DEVELOPED
PRELIMINARY OVERALL AREA DEVELOPMENT PLAN - P.O.A.D.P.
PRELIMINARY MASTER PLAN BY PLANNING UNIT
1,358.5 ACRES
2/5/88
WOODLAND HILLS
I.H.-10 NORTH
1 MILE
0 400 1000 2000 4000
10 ac.
1 ac.

WOODLAND HILLS - I.H. 10 NORTH

INFORMATION SHEET FOR
PRELIMINARY OVERALL AREA DEVELOPMENT PLAN
(P.O.A.D.P.)

RE: Woodland Hills Plan #248

PRELIMINARY OVERALL AREA DEVELOPMENT PLAN - P.O.A.D.P.

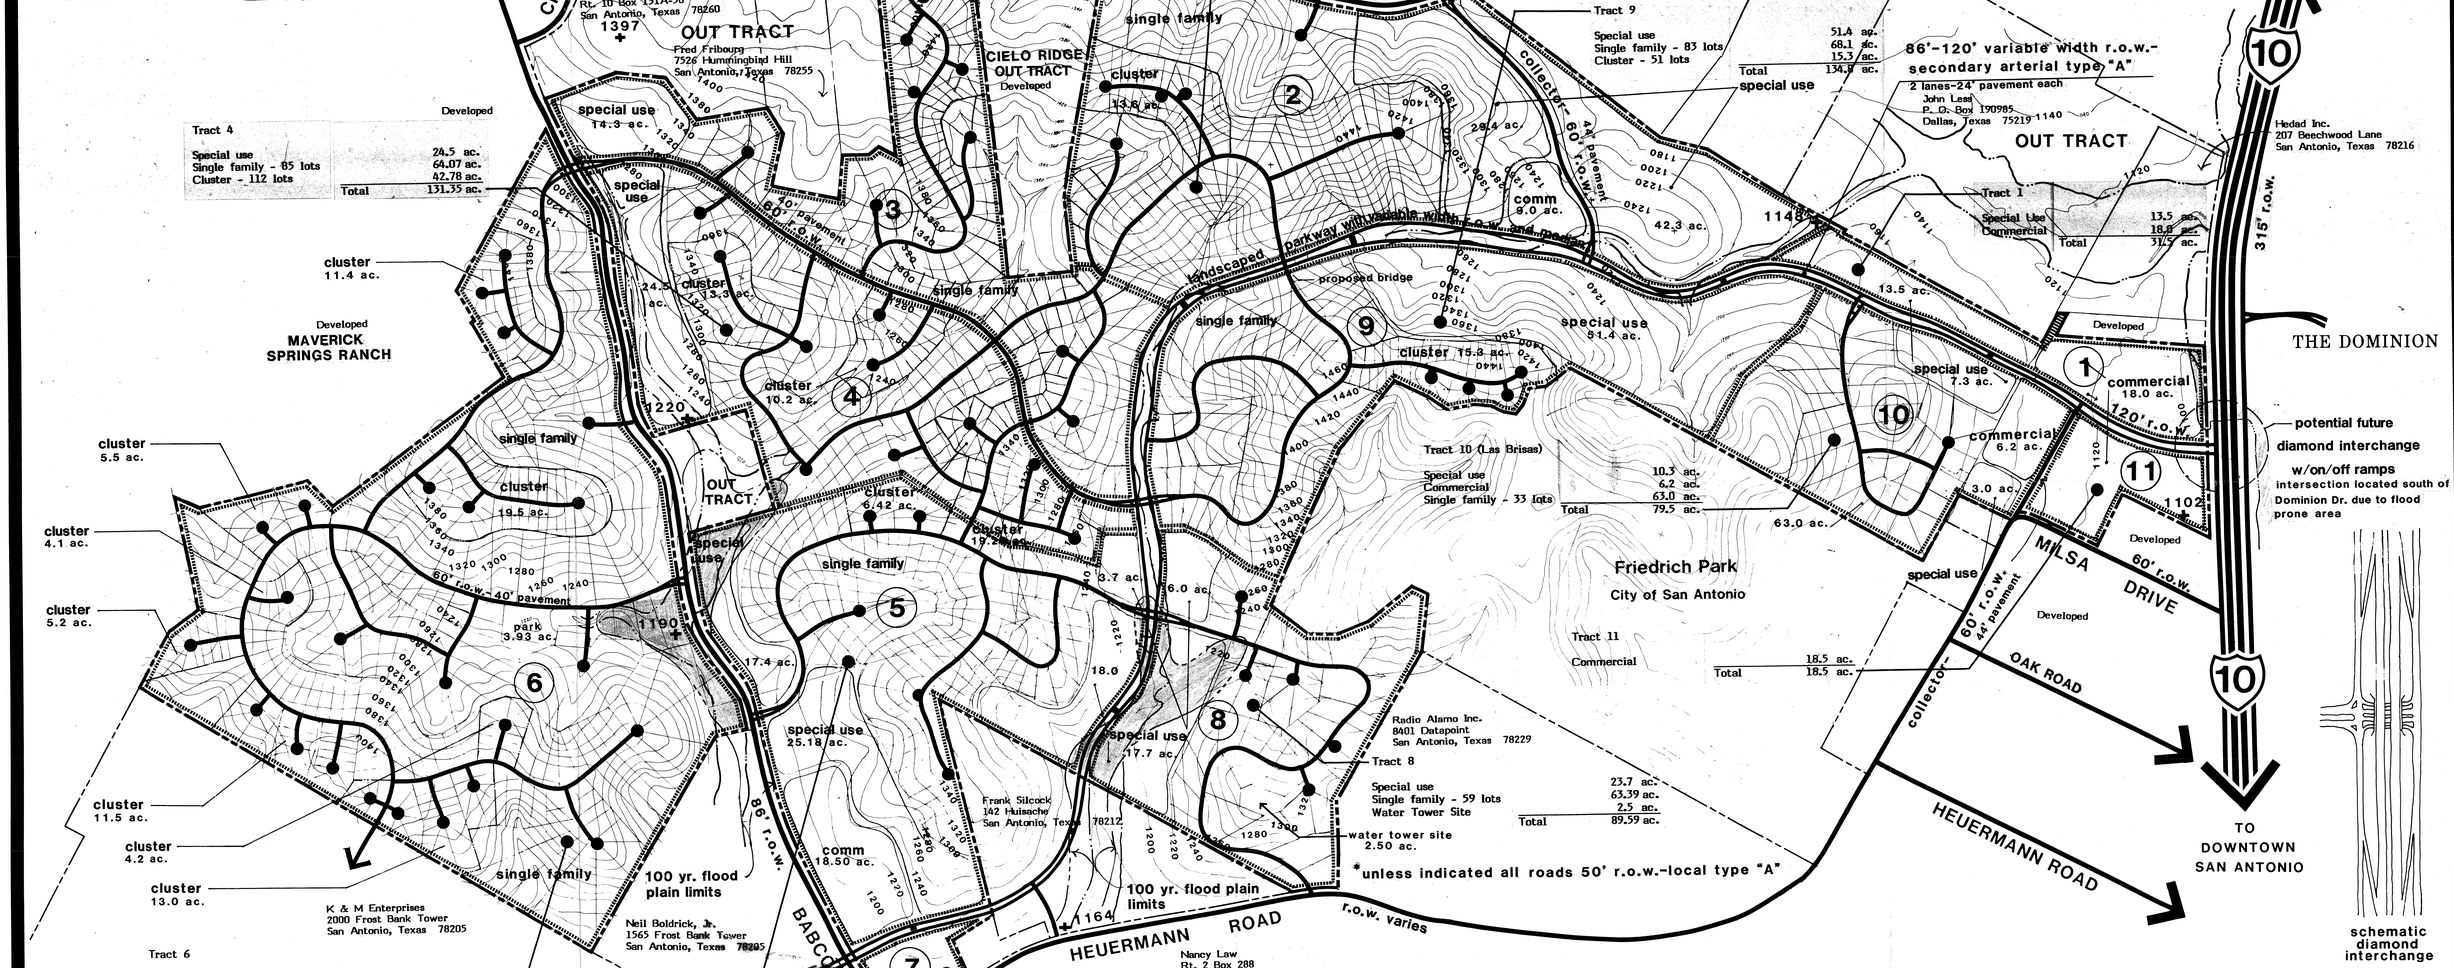
1) Proposed thoroughfare requires amendment to the M.T.P.
2) Committee is requesting that the thoroughfare be aligned with the Dominion Pkwy. Hwy Dept. concurs.
3) Investigate out tracts, ie what if any are developed or platted.
4) Need to identify collectors on plan.
5) You show one stub street on plan. Is it a collector street? has it been agreed to or discussed with the adjacent property owner?

(1) The proposed major Thoroughfare connection through Cielo Vista property intended to replace Hereman Road should be aligned with existing Dominion Road at IH 10 to service both sides of the Road

(2) The Location of the Diamond interchange on the Cielo Vista ROADP at IH 10 and the proposed new Thoroughfare had not been agreed upon by the Highway Dept.

(3) Due to the close proximity of the planned Hausman and Babcock Road interchanges at Loop 1604, spacing criteria makes it less feasible to extend the proposed north south Thoroughfare across Loop 1604

the issue on cuddesacs needs to be addressed with Fire Dept. & traffic. Stub streets need to be coordinated with adjacent property owners and they need to be collectors rather than locals.

Cedar Creek doesn't show any stub outs some provisions ~~[illegible]~~ for secondary access needs to be made to units 23 & 24 due to the terrain etc. we do not object to the two stub outs if they agree to extend them.

1. According to the engineer, if they align the new M.T. with Dominion Pk., that portion which links to I.H. 10 is in the 100 yr flood plain. The alignment as proposed is outside of the 100 yr. flood plain.
2. There are two collectors on the plan.
3. The Eng. will revise the plan and indicate the pavement width of said collectors and show the limits of the 100 yr flood plain along I.H. 10.
4. He will talk to Mr. Bender rep: stub street in area 6, ie it should be described as a 60' R.O.W.
5. Said Stub has been worked out with K&M and Mr. Bender is currently preparing a plan of the area for K&M.

• FIRE DEPT. TURN-AROUNDS

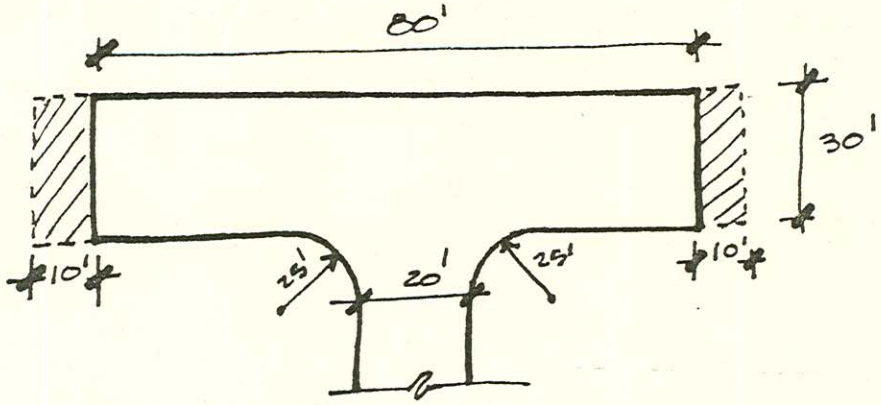
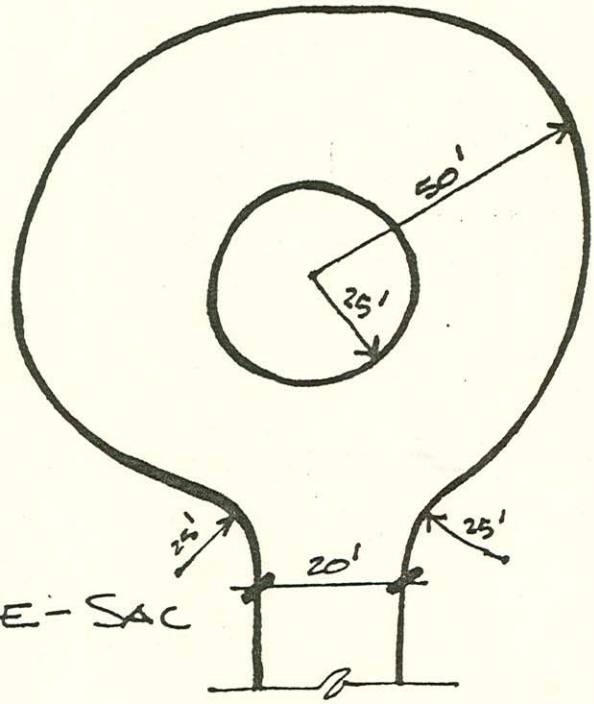
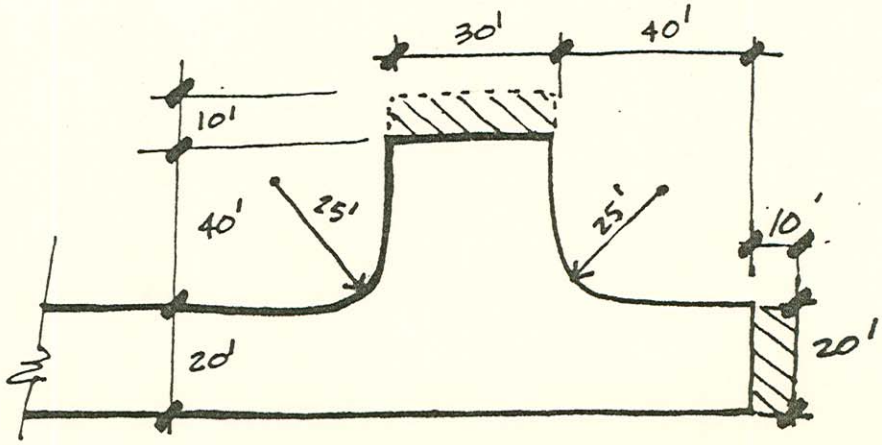
1. Our ladder trucks are needed at nearly every residential fire. Due to the approximately 47 foot length of the truck, a turnaround with a 50 foot radius to the curb line is needed. The option of backing up the truck as much as 1000 feet is not favorable, especially considering the good chance of having to backup while traveling downhill.

A turnaround for ladder trucks at the end of the cul-de-sac, and an intermediate turnaround for pumpers no more than 500 feet into the cul-de-sac would be more appropriate.

2. Any intermediate streets that would be used as a turnaround should be designed in a manner approved by the department. Attached is a copy of approved turnaround designs.

1. This item deals with the intermediate turnarounds that we have provided on the POADP. In addition, it also addresses a requirement for a 50-foot radius turnaround. Current City regulations for cul-de-sacs require a 50-foot radius to the right-of-way and a 40-foot radius to the curb line. When the Woodland Hills property is developed, we intend to comply with the subdivision requirements in place at that time.

2. It is our belief that all street intersections meet this criteria.
